Whole of House Verification – Stage 1

Department of the Environment and Energy
AECOM

Reference Group Feedback

Class 2: Typical 1990's

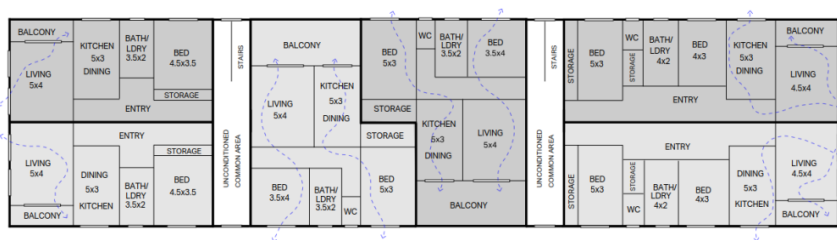
My experience with construction and living in apartments was 25-30 years ago in Wollongong and Sydney. They were all cavity brick with single brick internal walls and concrete floors. The better floor plans went from external wall to external wall through the building so crossflow ventilation was good unlike the plans supplied.

Noted. The floor plans have been updated in order to improve cross ventilation.
